Assessment Report

**Project: UNSW BUILDING E25 BIOLINK
REDEVELOPMENT**

Report Number: 240221

Revision: 04B

Typical Level – existing walls (outlined in blue) less than 6 m from E26:

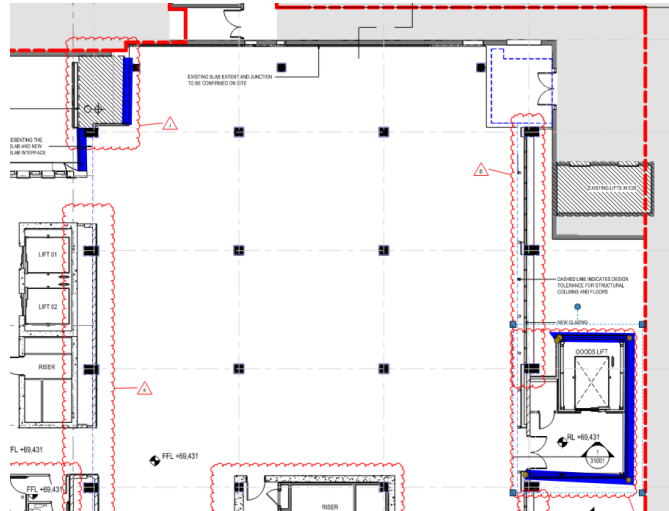
Any existing external walls proposed to be retained, and within 6 m of Building E26, that do not have the required FRL are to be reviewed by the fire engineer for consistency with the existing Fire engineering report prepared by Arup Ref 281879 rev A date 09.06.22.

Typical Level – walls (outlined in blue) less than 6 m from D26 & E26:

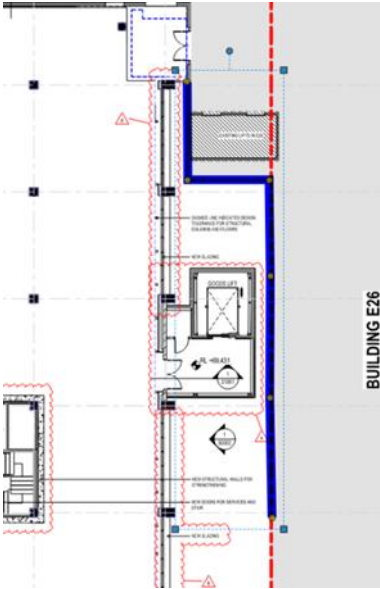
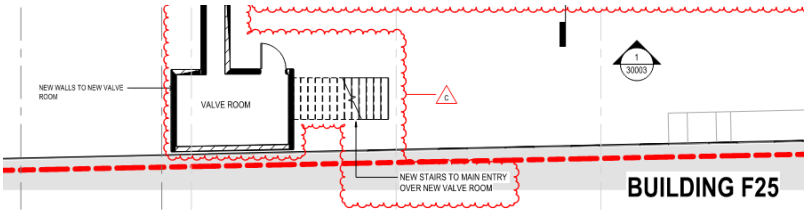
Any new non-load bearing external walls within 6 m of Building D26 or E26 are to have the required FRL of

- 2 hours on levels Ground to Level 2.

- 2 hours on Levels 3 to 5 in lieu of 4 hrs under performance justification
- 4 hours on Lower ground level

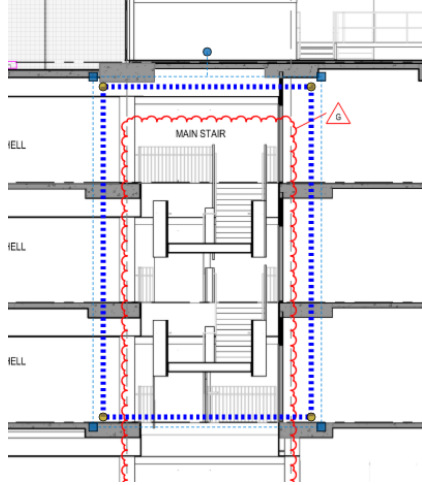
The proposed valve room on LGF must have the required FRLs, particularly in relation its proximity to Building F25.

Typical Level – glazed windows (outlined in blue) less than 6 m from E26 & D26:

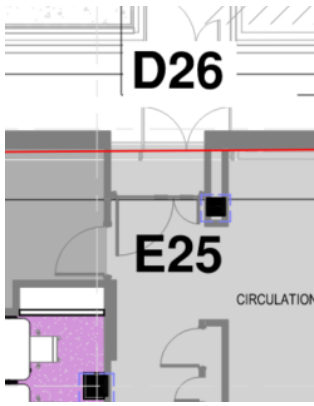
The new unprotected glazed windows within 6 m of Building E26 and D26 are to be performance justified:

Figure 2 – Location Plan of E25 and surrounding buildings.

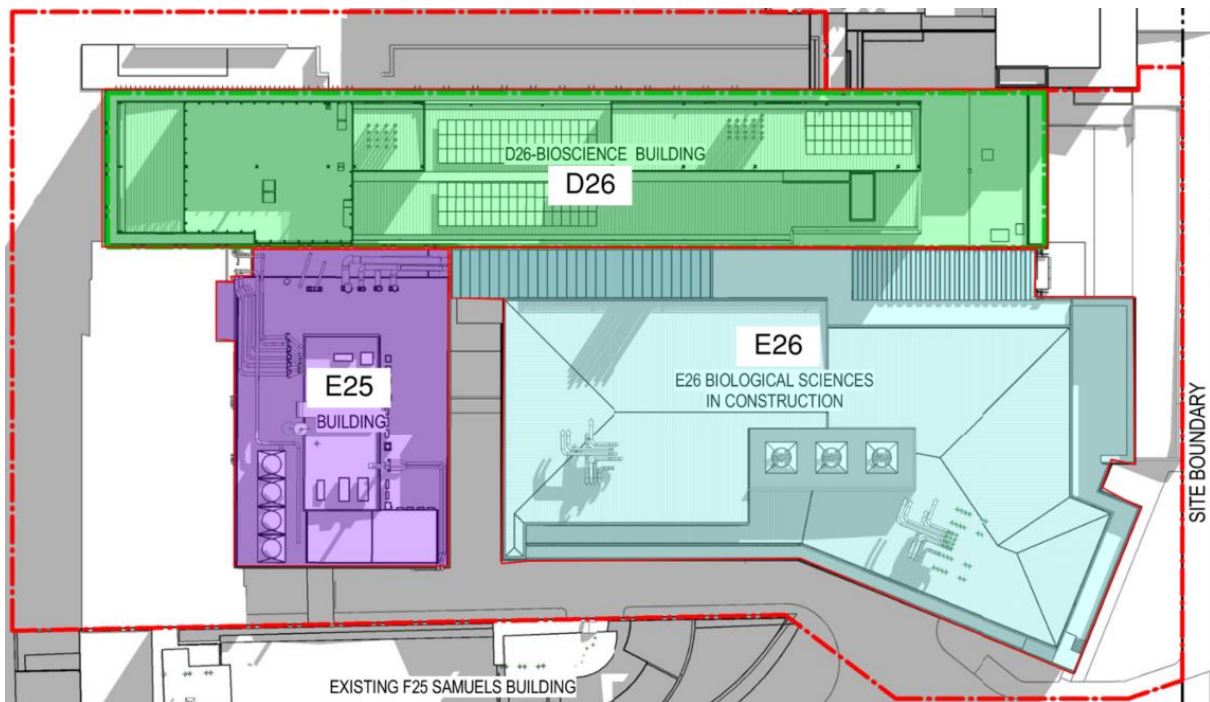
Building E25 has been assessed as a separate building to the attached Building E25 & E26 (Figure 2), for the purpose of BCA assessment, consistent with methodology outlined in the fire engineering report for Building E25 prepared by Arup Ref 281879 rev A date 09.06.22.

Typical Level – existing walls (outlined in blue) less than 6 m from E26:

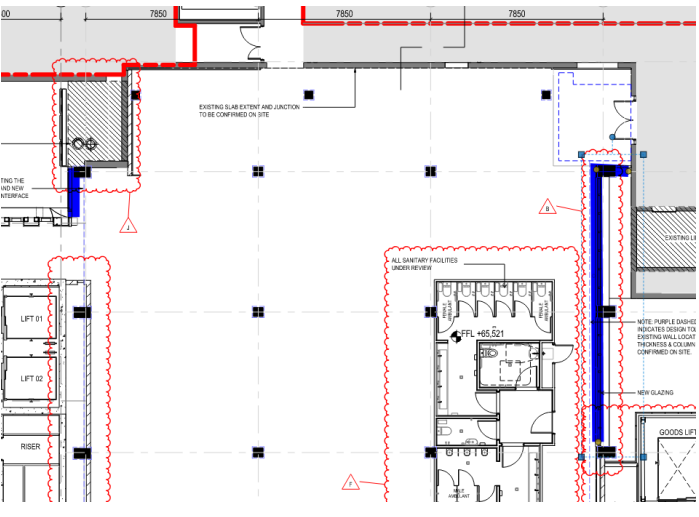
Class teaching	9b	
Level 1	Class 5 office Class 8 Labs Class teaching	9b	Class 9b teaching
Level 2	Class 5 office Class 8 Labs Class teaching	9b	Class 9b teaching
Level 3	Class 5 office Class 8 Labs Class teaching	9b	Class 5 Office Class 8 laboratories & Research facility/Animal Holding
Level 4	Class 5 office Class 8 Labs Class teaching	9b	Class 5 Office Class 8 laboratories & Research facility/Animal Holding
Level 5	Class 5 office Class 8 Labs Class teaching	9b	Class 5 Office Class 8 laboratories & Research facility/Animal Holding
Level 6 roof	Class 8 plant		Class 8 Plant
The Class 8 laboratory/animal holding/research on Levels 3 to 5 are to be performance justified to 2 hrs fire resistance in lieu of 4 hrs. Where the existing structure is less than 2 hr fire resistance, upgrade to 2 hrs is proposed. The Lower Ground Floor will be upgraded to achieve the required FRL of 4 hrs with the exception of the columns in external walls and radioactive stores which are proposed to be performance justified. The Class 9b levels Ground Floor to Level 2 are proposed to achieve 2 hours. Where the existing structure is less than 2 hr fire resistance, upgrade to 2 hrs is proposed. Any existing external walls proposed to be retained, and within 6 m of Building E26, that do not have the required FRL are to be

Typical Level – walls (outlined in blue) less than 6 m from D26 & E26:

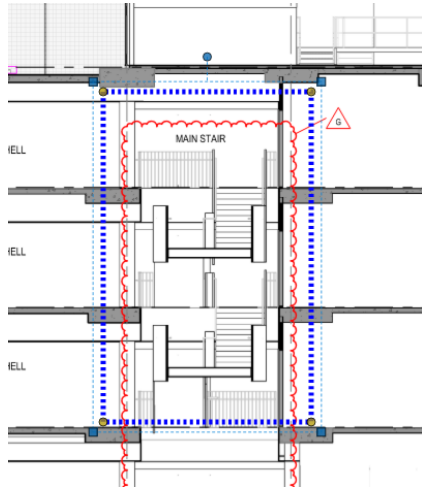
- 2 hours on levels Ground to Level 2.
- 2 hours on Levels 3 to 5 in lieu of 4 hrs under performance justification
- 4 hours on Lower ground level
